PUBLIC INTEREST REVIEW FOR GROUNDWATER APPLICATIONS

TO: Water Rights Section Date August 31, 2016
 FROM: Groundwater Section J. Hackett
 SUBJECT: Application G- 18363 Reviewer's Name J. Hackett
 Supersedes review of _____ Date of Review(s) _____

A. GENERAL INFORMATION: Applicant's Name: Gary & Karen Wilde County: Gilliam

Water-Level Trends in Nearby Wells

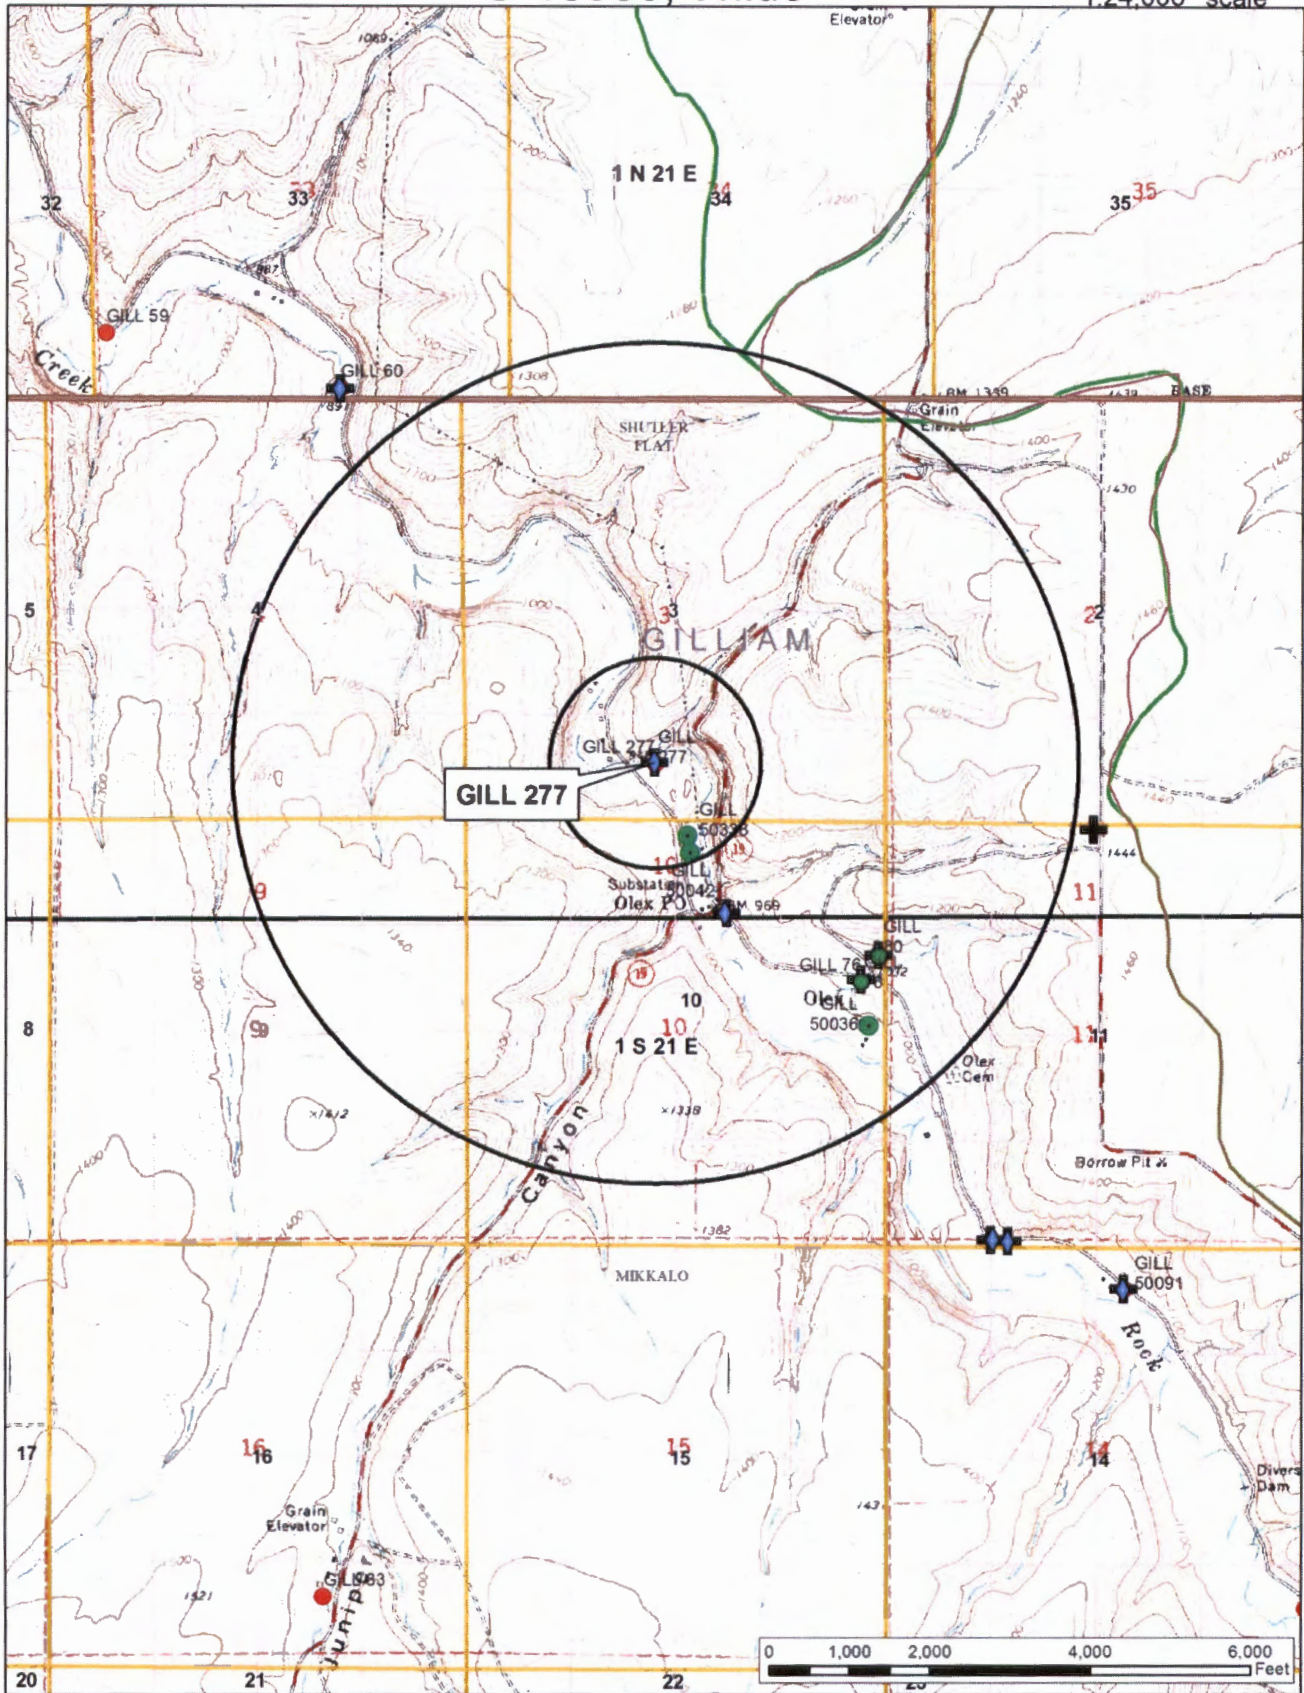
Local geologic mapping (Swanson and others, 1981; Anderson, unpublished mapping) indicates that the applicant’s well should encounter the following basalt flow units from shallow to deep: Frenchman Springs Member of the Wanapum Basalt Formation and Sentinel Bluffs Basalt of the Grande Ronde Basalt Formation. The well log identifies two water-bearing zones (396-412 feet below land surface and 525-530 feet below land surface), that are both likely in the Sentinel Bluffs Basalt. Water levels in nearby State Observation Well GILL 60 have been fairly stable over the past two decades; however, it is uncertain if GILL 60 is completed in the same aquifer as the applicant’s well (see attached hydrograph).
